memorandum

subject Technical Review Memorandum for the De Anza Natural Amendment to the Mission Bay Park Master Plan Draft Program Environmental Impact Report, Sch #2018061024

Figure 1. Draft Land Use map from the 2023 Mission Bay Park Master Plan Amendment

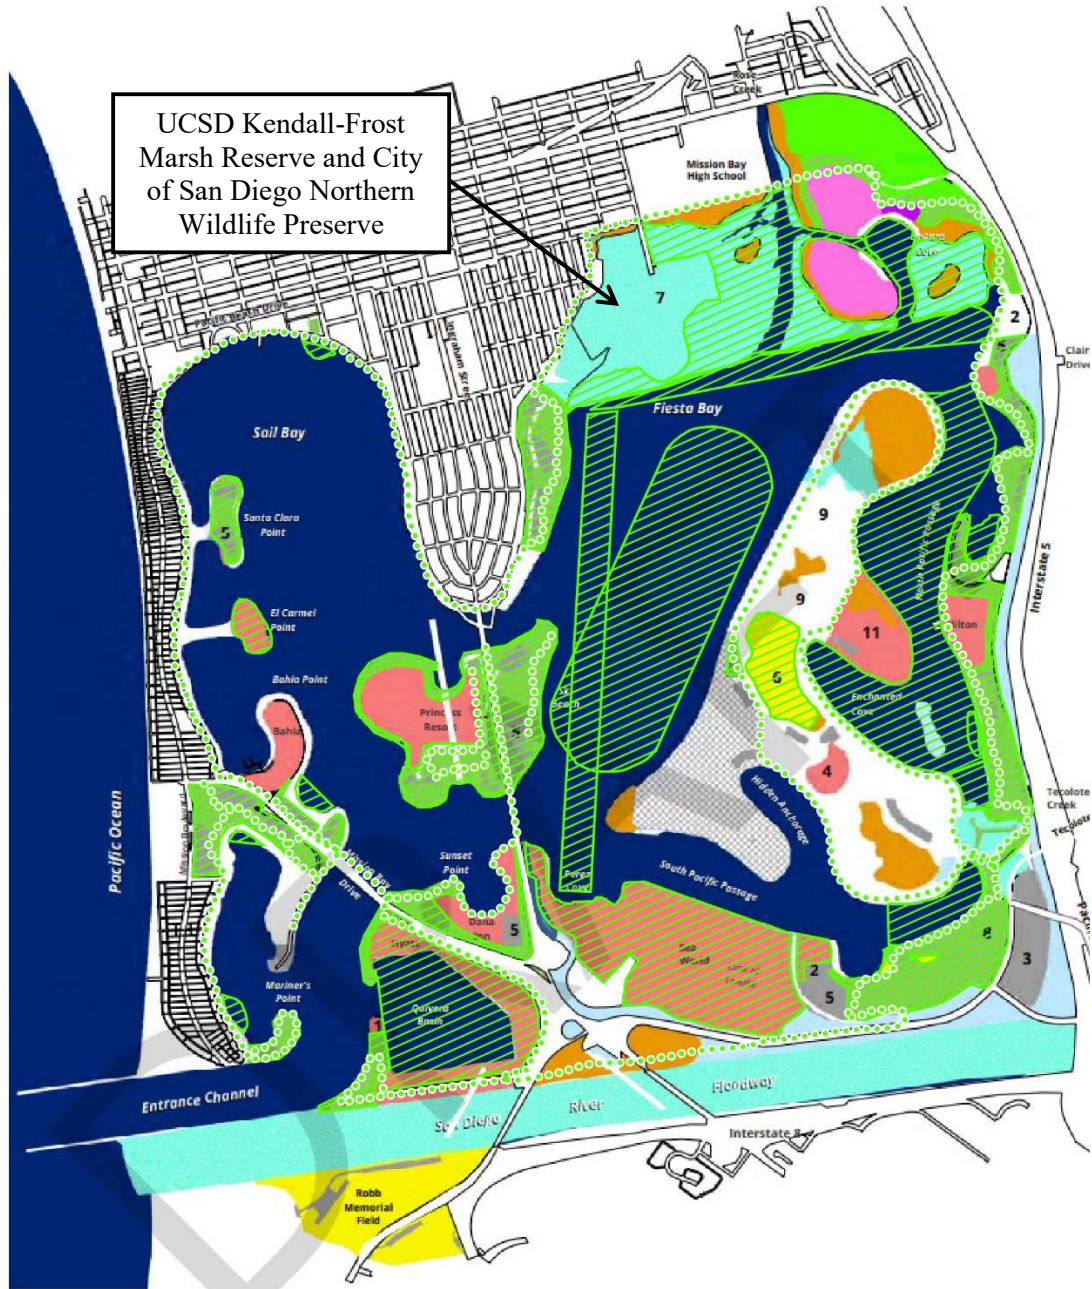
provided in the 2023 Mission Bay Park Master Plan Amendment (**Figure 1**), most of the perimeter of Mission Bay is designated as parkland, active recreation, open beach, or play fields, while a minority is designated as wetland habitat. A large portion of the designated wetland habitat that is included is the San Diego River Floodway, which is disconnected from Mission Bay. Also, note that the San Diego River downstream of W. Mission Bay Bridge is designated as wetland habitat, but is actually mostly “open water”. Land use decisions should be based on an assessment of acreages of land use types for the entire Mission Bay Park as well as an analysis and assessment of land use by land use type.

The current Land Use map underestimates the availability of space for active recreation that already exists in Mission Bay. The PEIR defines active recreation as activities including “land-based active recreational pursuits, including sand volleyball, over-the-line, walking, bicycling, and in-line/roller skating” (pg 2-4). **Figure 2** shows that there are significant areas of Mission Bay that could be considered active recreation and that are not shown on the Land Use map, including playfields, walking/biking paths, and lease area active recreation, including Sea World, Quivira Basin, and Mission Bay Yacht Club. The City of San Diego’s website advertises “close to 14 miles of bike paths along Mission Bay.”¹ The PEIR also states that “regional parkland supports activities such as picnicking, kiteflying, Frisbee throwing, informal sports, walking, jogging, bicycling, and in-line/roller skating” (pg 2-4). By this definition, all of the regional parkland could be considered active recreation areas. There are also significant portions of Mission Bay that could be considered open water active recreation. The land use map and analysis should include all types of active recreation for the entire park.

Figure 3. Mission Bay exposure to storm surge and sea level rise.

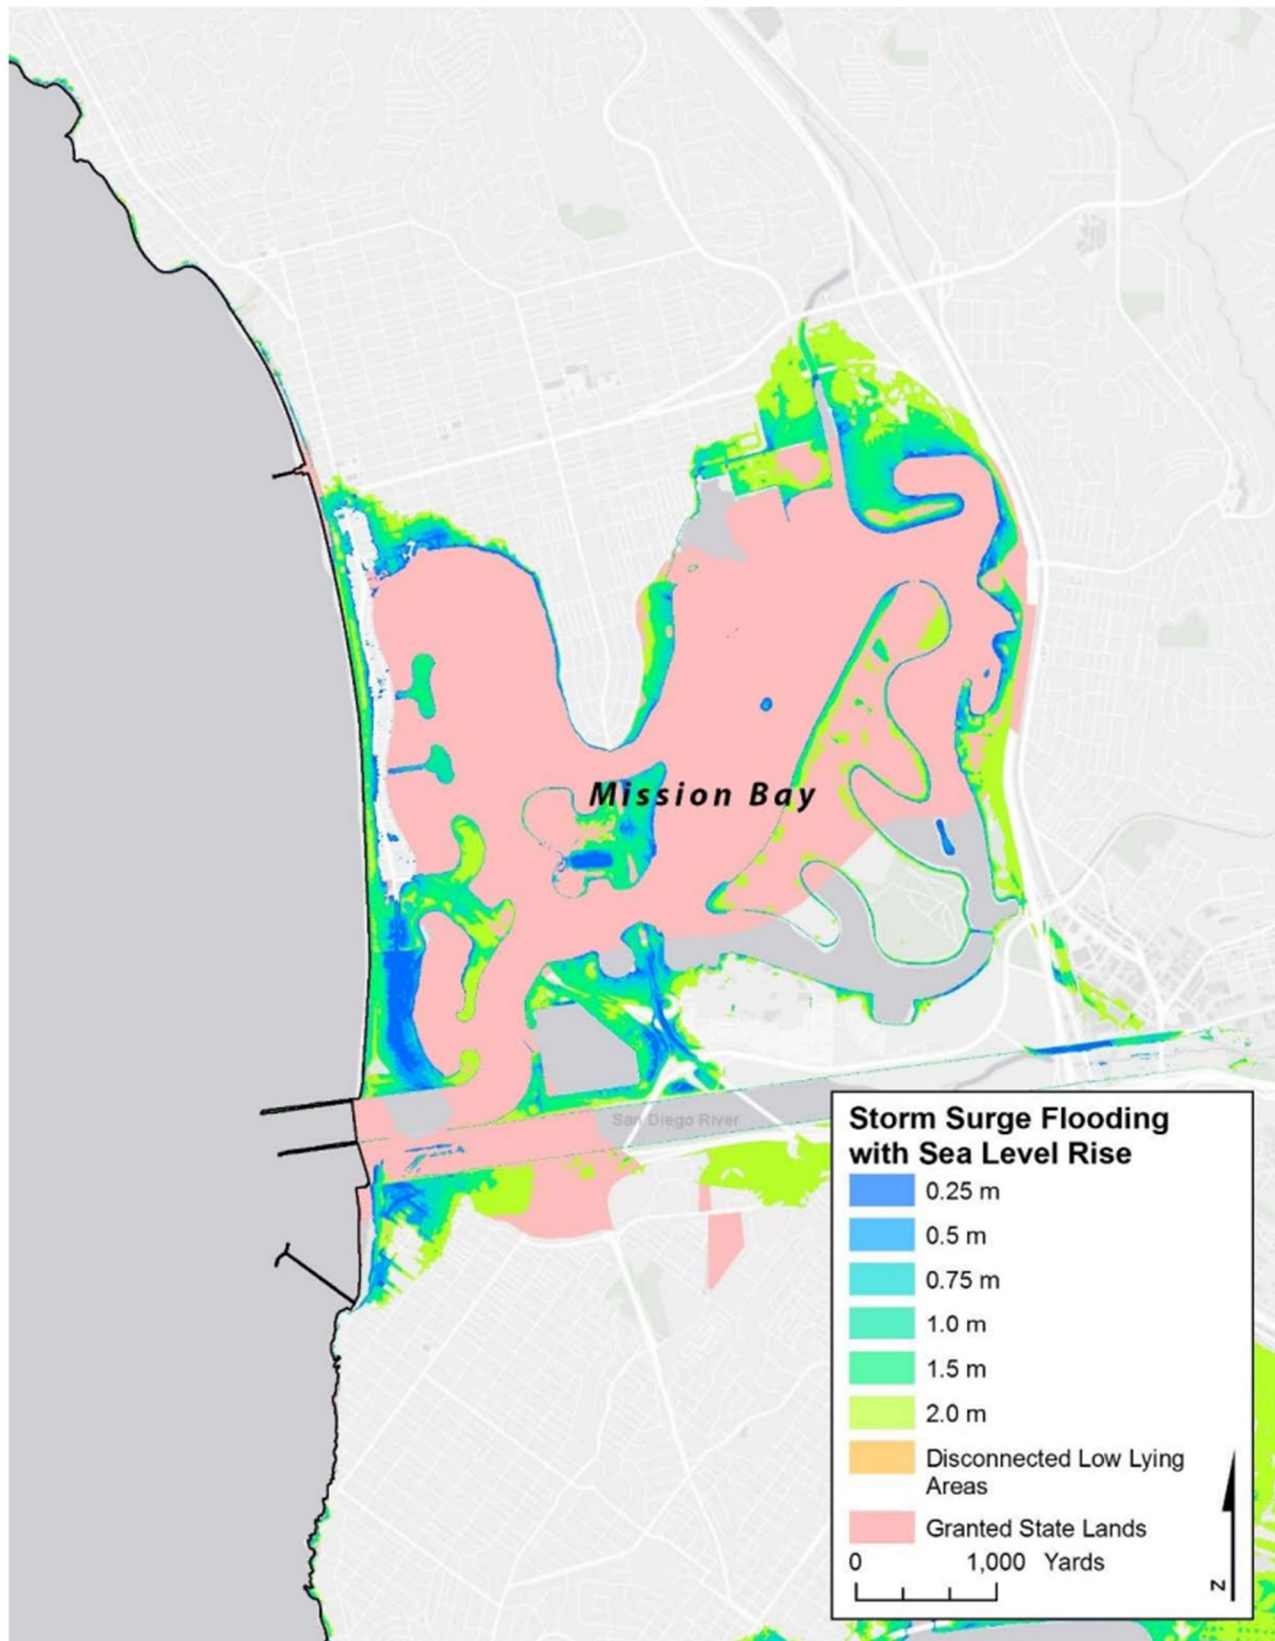
The project area is vulnerable to future sea level rise. In the City’s Sea Level Rise Vulnerability Assessment (ICF 2019), ICF used U.S. Geologic Services (USGS) data to map sea level rise around Mission Bay, as shown in **Figure 3**. A zoomed in version of the USGS data for 6.6 feet of sea level rise with a 100-year storm for the project area is shown in **Figure 4** (CoSMoS v3.0; Barnard et al. 2018). It should be noted that these maps do not show extreme Rose Creek discharge, which will have additional flooding impacts.

In both Section 5.7.3.1 and Appendix I, the PEIR mentions: “With implementation of the Proposed Project, De Anza Cove is expected to experience lowered levels of inundation and velocities by 2100 compared to if the area is left in its current state, as a result of proposed wetland restoration activities, which would increase resilience to sea level rise and coastal flooding.” However, the report does not include a sea level rise assessment nor discussion of impacts due to potential adaptation strategies that will be needed to protect developed areas, such as sea walls, revetments, or berms. Without a sea level rise assessment, it is not possible to assess the impacts of the project, even at the program level.

Figure 1
Wetlands Optimized Alternative Approximate Terrain

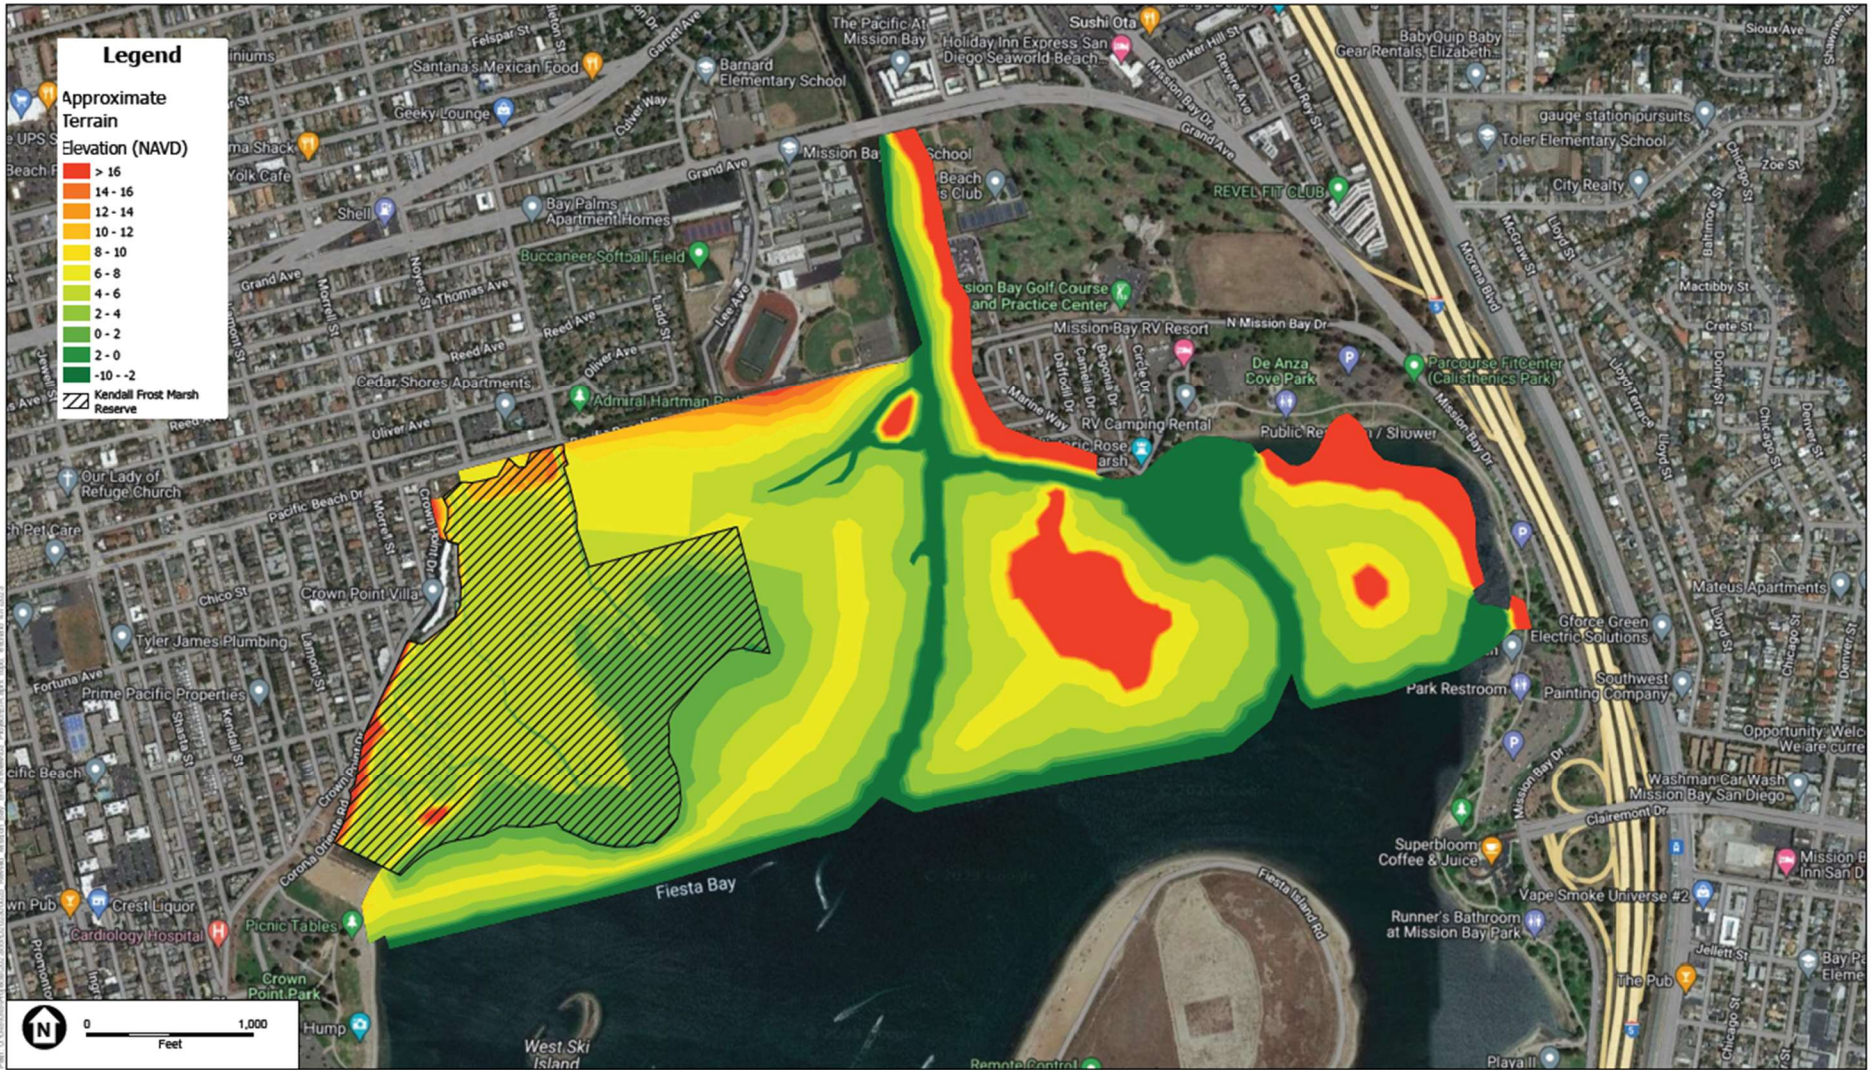
Marsh habitat acreages for 2100 were estimated for the Wetlands Optimized Alternative using the wetlands and uplands areas in PEIR Figure 8-1. ESA developed an approximate terrain by assuming an elevation of 2.9 ft NAVD (lowest saltmarsh elevation discussed above) at the edge of the proposed wetland, an elevation of 6.9 ft NAVD at the inland wetland boundary, and a maximum of 3:1 slope. Varying terrain was assumed in some areas to provide a range of marsh elevations in wetland areas including a high marsh ridge line in the proposed wetland adjacent to Kendall-Frost Marsh, a high marsh ridgeline along the southwest point of the proposed marsh island, and a mid-marsh dip between the two upland areas east of De Anza Cove. The approximate terrain is shown in Figure 1. As mentioned previously, the terrain is entirely assumed based on the wetland extent provided by the PEIR. The PEIR does not provide information about habitat distribution or topography within the wetland area.

Figure 2
Wetlands Optimized Alternative Marsh Habitats
Post-Construction (Left) and 2100 (Right)

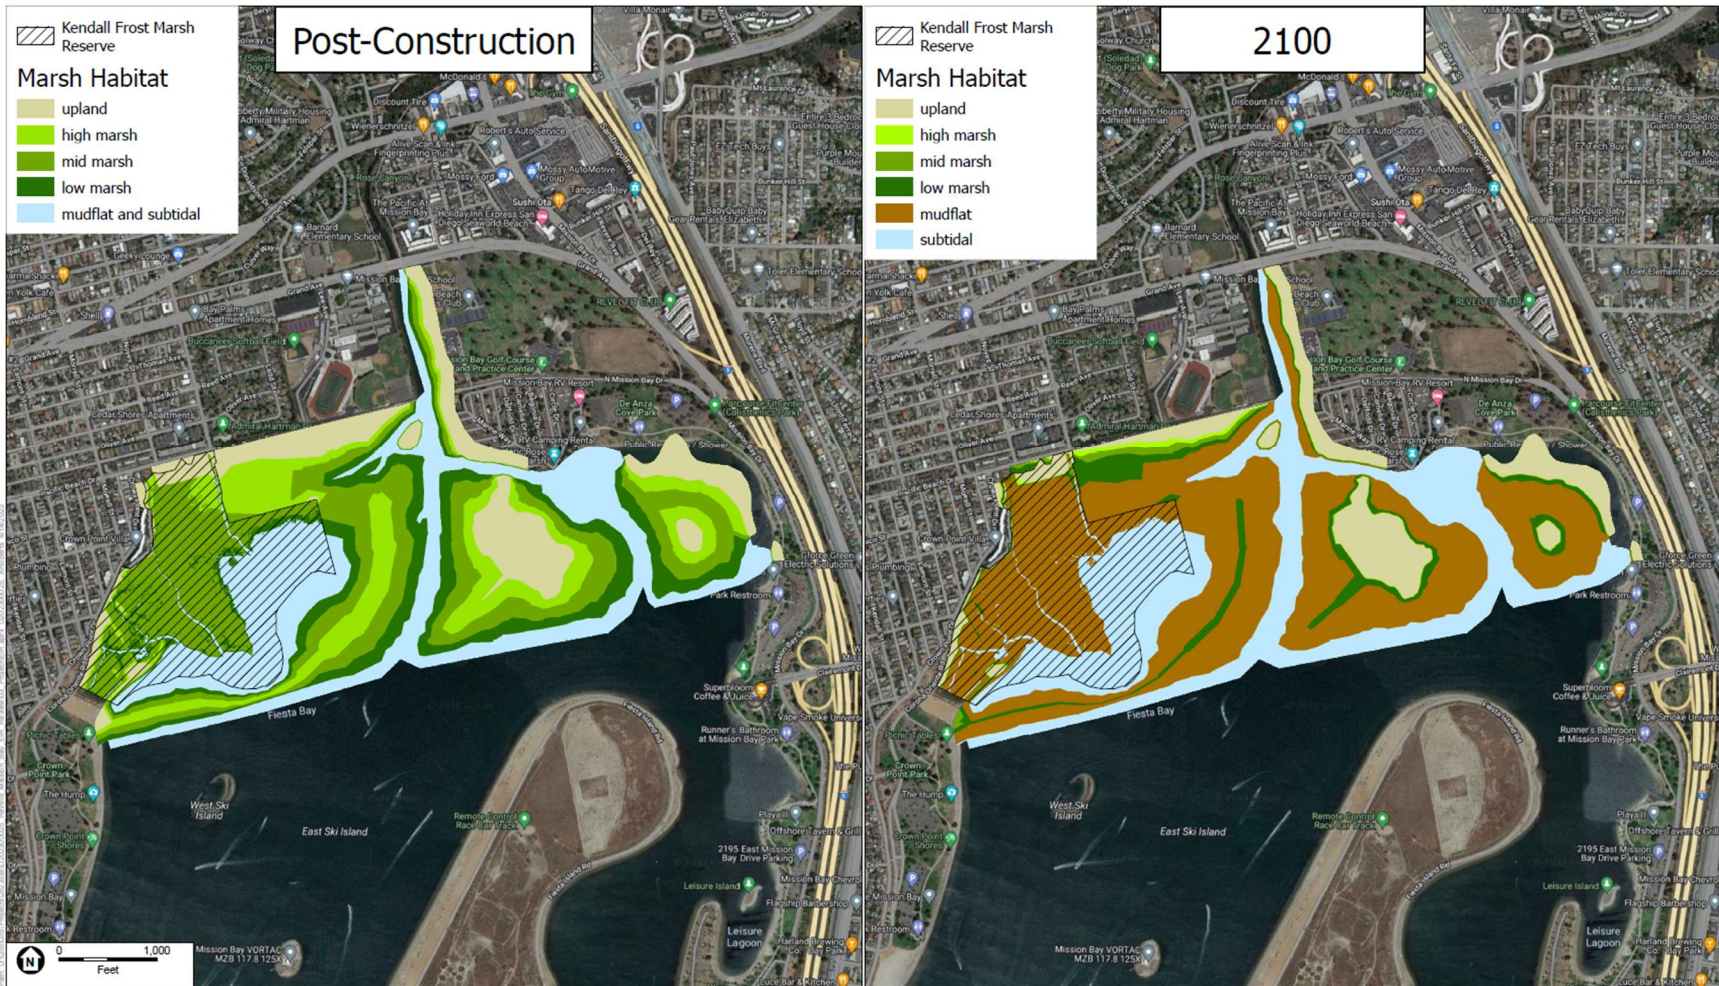
ESA developed a habitat evolution model for the Wetlands Optimized alternative (Attachment A) assuming all habitat shown in the figure would start as salt marsh. Assuming 3.6 feet of sea level rise by 2100 would result in only 28 acres of salt marsh remaining at the end of the century, with the majority of the site (124 acres) converting to mudflat. To meet the intention of the SEP, the City may consider reducing the amount of development surrounding the habitat and including more upland habitat that would allow the wetland to move upslope within the planning horizon of this plan, similar to the “Wildest” alternative, which would result in 75 acres of wetland by 2100.

Table 2 shows the results of the analysis. Total wetland area in 2100 (including mudflat, but not including Kendall-Frost Marsh) is estimated to be approximately 152 acres. In 2100, mudflat comprises a majority of the total wetlands area at 124 acres while low, mid, and high marsh combined comprise only 28 acres (Figure 2). Because the current plan is estimated to result in mostly mudflat habitat compared to salt marsh habitat, more of the upland and future marsh area should be set as undeveloped and graded at a very shallow slope. This would allow for the salt marsh habitat (low, mid, and high marsh) to have more room to move upslope as sea levels rise and increase the likelihood of this important habitat remaining through 2100.
